Access Compliance Report

Public Rights-of-Way

(Curb Ramps)

Intersection ID: 47920	Main Street: RINGNECK_RD	Cross Street: ROOK_RD	Location: SE
ADA ID: 6800076BE7B7	Ramp Type: PerpDiag	Initial Pass/Fail: Fail	Overall Compliance: No
Codes/Mitigation Info/Possible Solution		Field Measurements/Component Compliance

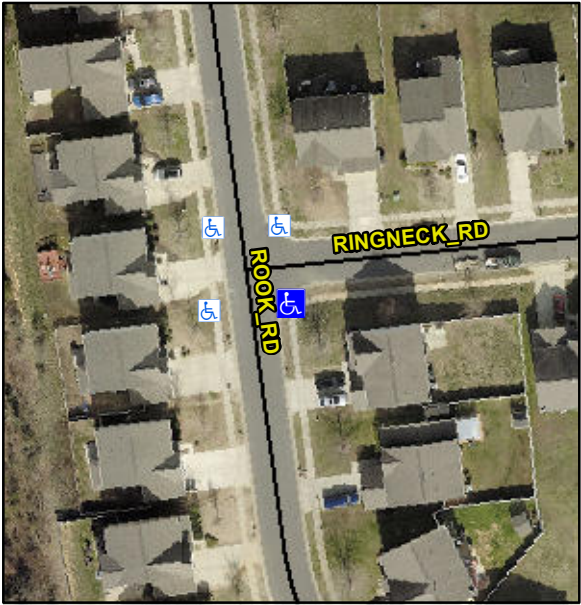
Possible Solutions:		Compliance	Description	Data	Compliance	Description	Data
	Remove & Replace Curb Ramp With Two New Directional Ramps or Equivalent.		N/A	Ramp Length (in)	49.5	No	Ramp Slope (%)	9.4
<p>Surveyor Notes:</p> <p>N/A</p> <p>PROW/ADA:</p> <p>R304.2.2, R304.5.3</p>			Yes	Ramp Width (in)	48.0	No	Ramp XSlope (%)	2.6
			N/A	Flare Type LT	N/A	N/A	Flare Type RT	N/A
<p>Street 1 Name</p> <p>Stop Condition-Street 2</p> <p>Street 2 Name</p> <p>Stop Condition-Street 1</p>			N/A	Flare Slope LT (%)	N/A	N/A	Flare Slope RT (%)	N/A
			N/A	Flare Traversable LT?	N/A	N/A	Flare Traversable RT?	N/A
<p>Total Cost:</p> <p>\$ 3200.00</p>			N/A	Landing Length (in)	N/A	N/A	DWS Provided?	N/A
			N/A	Landing Width (in)	N/A	N/A	DWS Contrast?	N/A
			N/A	Landing Slope (%)	N/A	N/A	DWS Length (in)	N/A
			N/A	Landing X Slope (%)	N/A	N/A	DWS Full Width?	N/A
			N/A	Landing Curb? (Y/N)	N/A	N/A	DWS Offset (in)	N/A
			N/A	Shared Landing?	N/A	N/A	Gutter Slope (%)	N/A
